STAFF REPORT Land Division

SD-03-10

Subdivision Tentative Plat that will divide a 9.58-acre parcel of land into 30 residential single-family lots (Laurel Highlands).

The applicant submitted a Subdivision Tentative Plat application. The subdivision would divide a 9.58-acre parcel of land into 30 residential single-family lots (Laurel Highlands).

PROPOSED SUBDIVISION

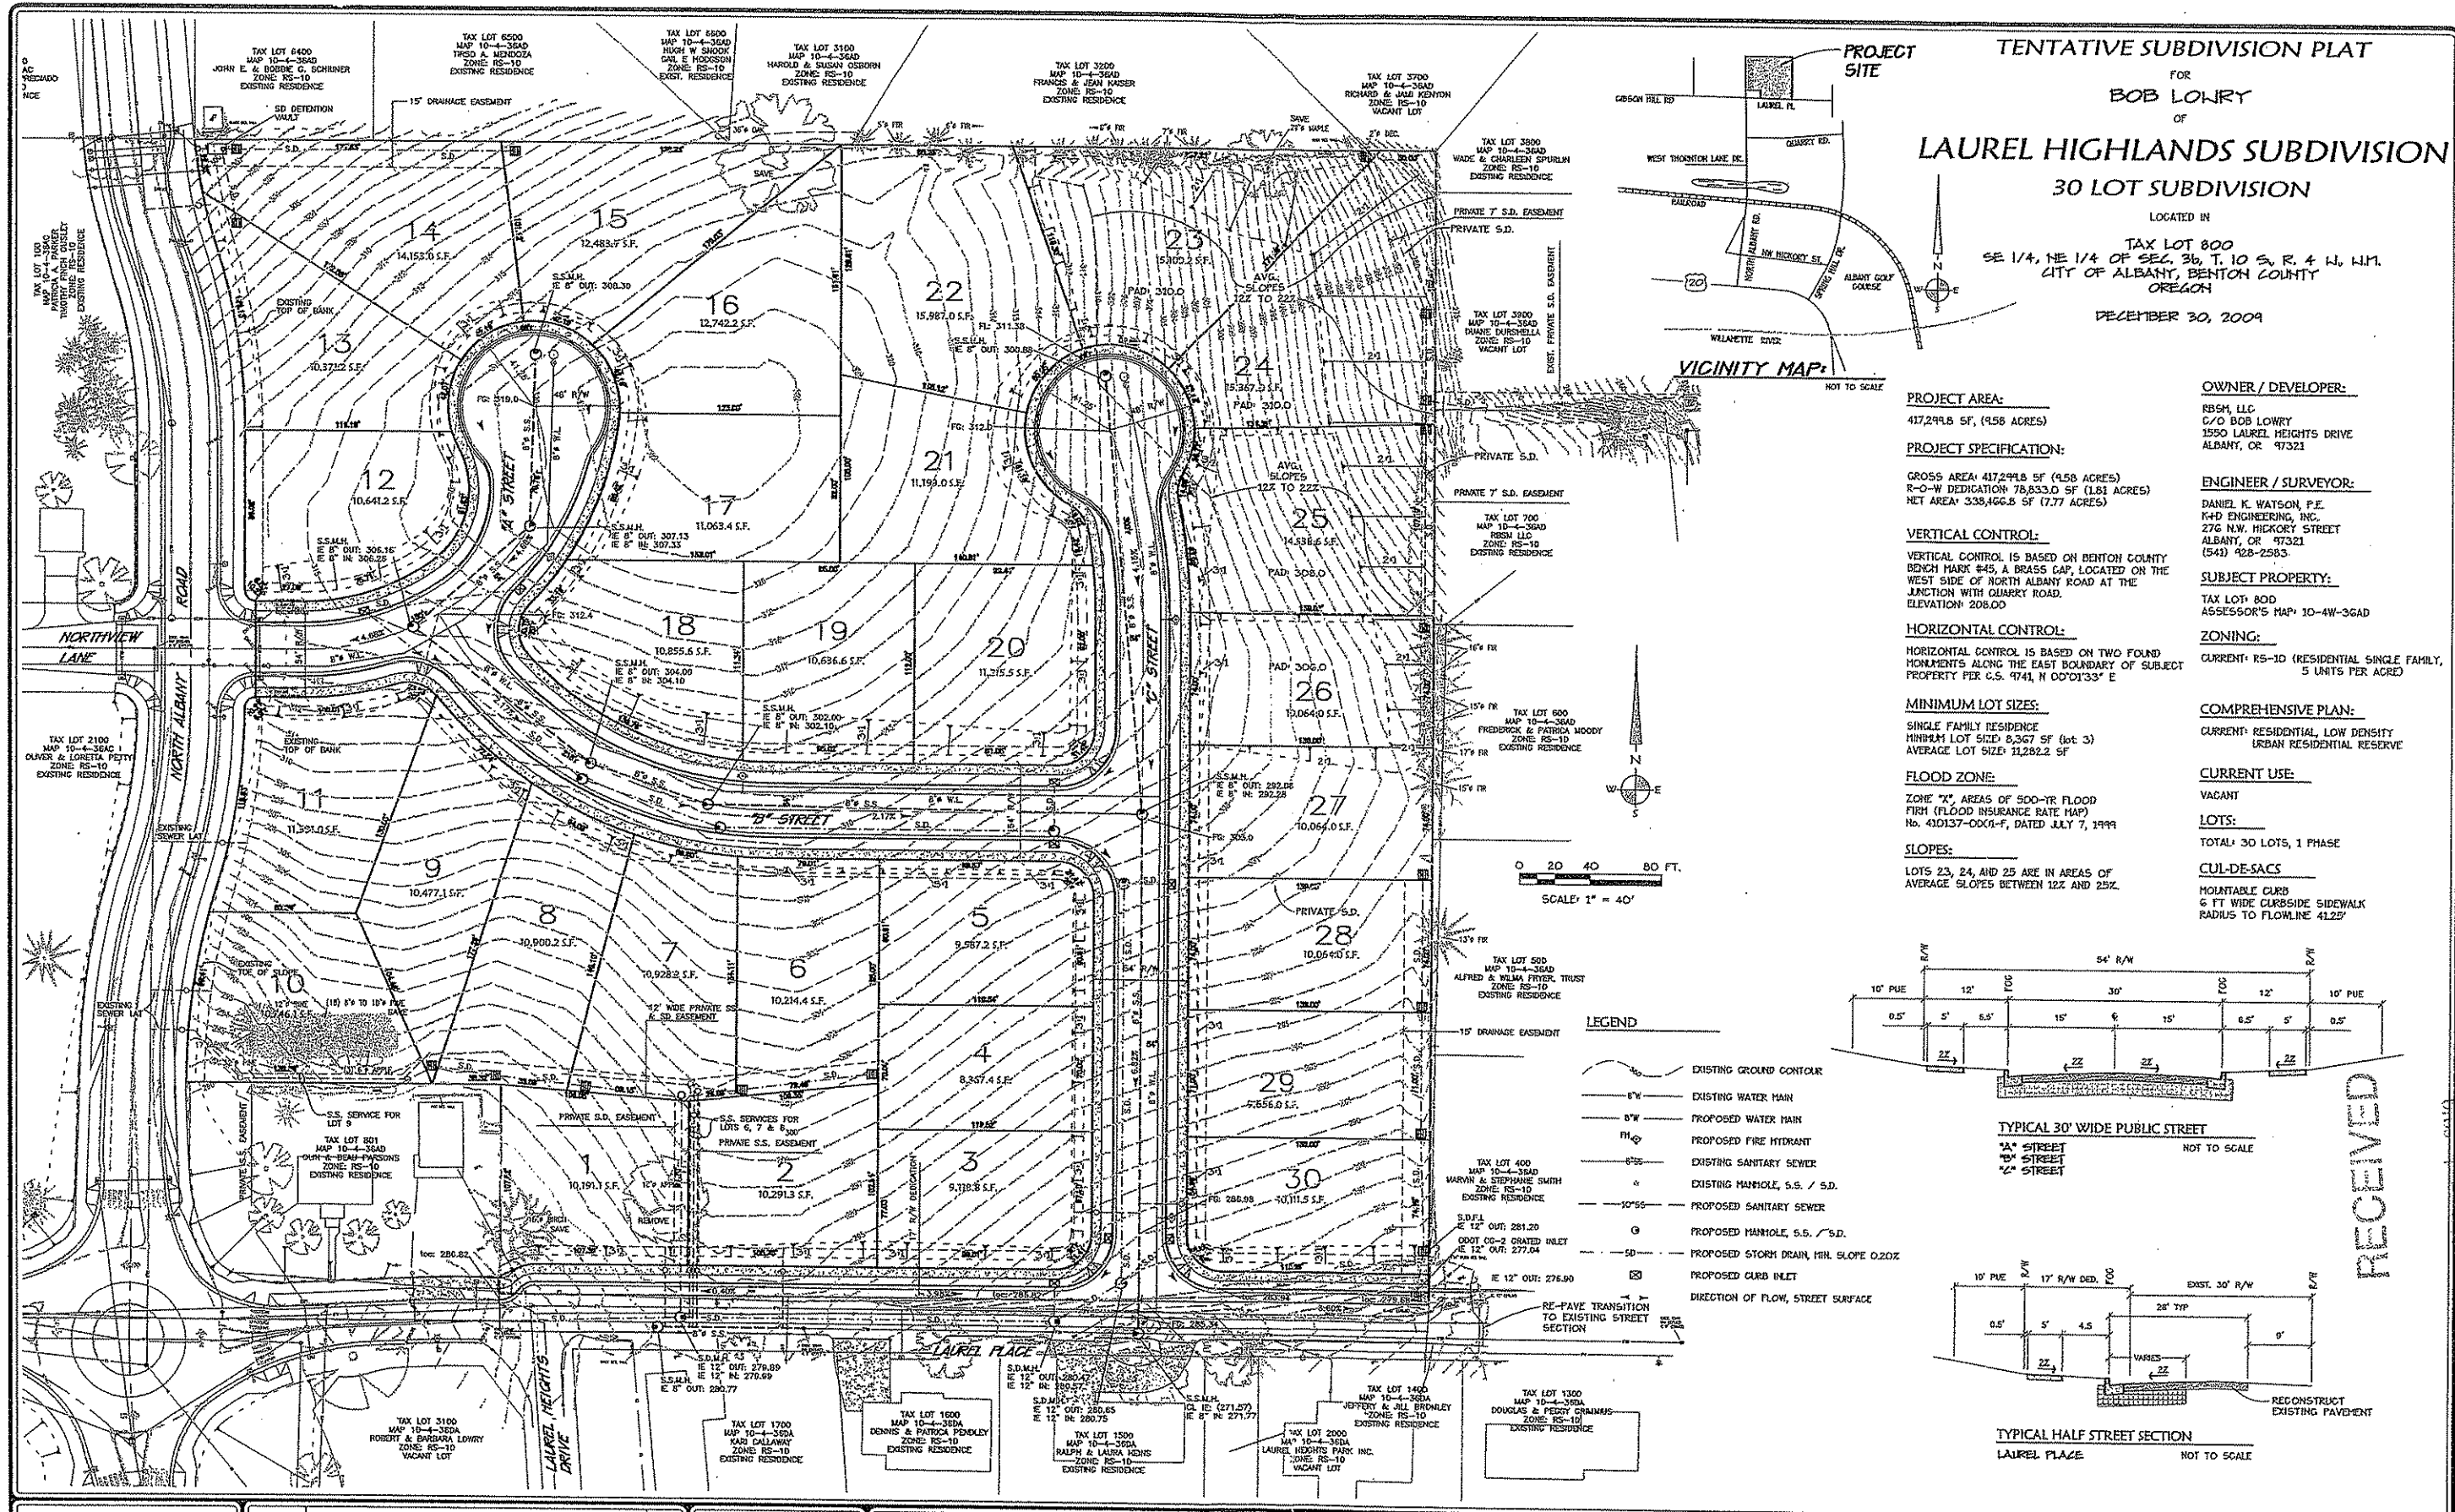
- 3.6 The interior streets within the subdivision would be classified as local streets. The tentative plat shows that all have a right-of-way width of 54 feet, and curb to curb width of 30 feet. That design complies with

- 3.10 Laurel Place adjoins the subdivision and currently is not built to City standards. The applicant proposes to dedicate 17 feet of additional right-of-way on the north side of Laurel Place and construct a 28-foot-wide partial street.

- 4.7 The applicant's preliminary utility plan shows an extension of approximately 85 feet of public 8-inch sewer main in Laurel Place to provide sewer service to Lots 1, 2, 6, 7, and 8. The plan also shows public 8-inch sewer main extensions into the site within the proposed streets to provide sewer service to the other lots that will not have access to existing public sewers. Lots 9, 10, 11, 13, and 14 will have access to existing sewer laterals that were installed when the North Albany Road extension was constructed.

- 4.12 The applicant's preliminary utility plan shows the extension of 8-inch public water mains within the proposed streets of the subdivision to provide service to each of the lots except Lots 1, 2, and 10. Lots 1, 2, and 10 will be served by water services installed by City personnel from existing water mains in North Albany Road and Laurel Place. Water service installation permits must be obtained by the applicant before these services will be constructed.

- 4.16 The applicant's preliminary utility plan shows the construction of public storm drainage improvements within the proposed streets to be built in association with this subdivision. The majority of the street runoff will be collected by catch basins within the streets and carried through pipes to the existing public drainage facilities in Laurel Place, which will then flow to public drainage facilities in North Albany Road. A small amount of street runoff will flow to the east in Laurel Place and to the west at the intersection of North Albany Road and Northview Lane. The slope of the property is such that some of the proposed lots along the north portion of "C" Street will not be able to drain roof drains to the curb. In order to provide for drainage of hard surfaces to the public storm drainage system the applicant must construct a public storm drainage main in "C" Street north of "B" Street and provide individual storm drainage service laterals to each of the lots which cannot be served by roof drain connections to the curb.

- 4.17 Because of the slope of the subject property, the applicant's plan shows private storm drainage facilities to be constructed along the rear of the lots along the north and east boundaries of the subject property. Drainage from the back of Lots 13, 14 and 15 will be collected in a shared private drainage system and carried to a connection to the existing public storm drainage main in North Albany Road, near the subject property's northwest corner. Included in the design of this private system is a private storm drainage detention vault at the extreme northwest corner of Lot 14. A shared maintenance agreement must be created to assure that the private drainage system and this detention facility is properly maintained and continues to function as designed.

- 4.5 The applicant's preliminary storm drainage plan appears to be acceptable, but a public storm drainage main must be extended to the north end of "C" Street to provide service to those lots whose roof drains (and other hard surfaces, such as driveways, etc.) cannot be drained to the adjacent curb.

"A", "B" and "C" Streets in the subdivision will be classified as local streets. The Tentative Plat shows that "A" Street will be 4.68 percent grade. "B" Street will be 2.17 percent grade. "C" Street will vary from 4.15 percent to 6.82 percent grade. Driveway grades will be established when building permits for houses are issued. The restriction on the steepness of driveways will be included as a condition of approval of the subdivision.

- 3.1 The property owner shall dedicate 17 feet of right-of-way along the development's frontage on Laurel Place.
- 3.2 Before the City will approve the final subdivision plat, the property owner/developer shall construct or financially assure the construction of partial street improvements along the subdivision's frontage on Laurel Place Drive. The improvements shall include:

- Installation of curb and gutter on the north side of the street. The face of curb shall be located 37 feet north of the current south right of way line of the street.

- Installation of sidewalk to City standards along the Laurel Place frontage of lots 1, 2, 3, and 30.
 - Installation of new pavement to City standards to a width of 28 feet as measured from the new face of curb along the north side of the street.

- 3.3 The subdivision's interior street system shall be constructed to City standards. The right-of-way and curb to curb widths shall be as shown on the tentative subdivision plat.

- 4.1 Before the City will approve the final subdivision plat, the property owner/developer must construct public sanitary sewer, water, and storm drainage system improvements to serve the proposed development. These improvements must generally conform to the plans submitted to the City with the subdivision tentative plat application. One modification to the submitted plans that must be included with the final review of the public utility plan review is the extension of a public storm drainage main within the north portion of "C" Street.
- 4.2 At the time of the final plat submittal, the property owner/developer shall show provision of private utility maintenance agreements for each shared private storm drainage facility proposed along the rear boundaries of the lots.
